Illustrated Parts List - IPL Update

372 XP X-TORQ

1. Ignition module

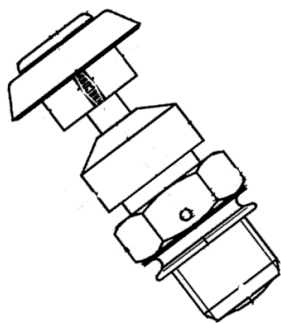
1. New Ignition module. New start curve. This update together with the new decompression valve improve startability of hot product and/or avoid misfire
2. New decompression valve to cylinder. Hole Ø1mm was Ø1.2mm
3. New tank cap and gasket. Reason is new supplier

Fully interchangeable
To improve startability of hot product and/or avoid misfire we recommend changing both ignition module and the decompression valve.

588 93 74-03

586 88 03-03
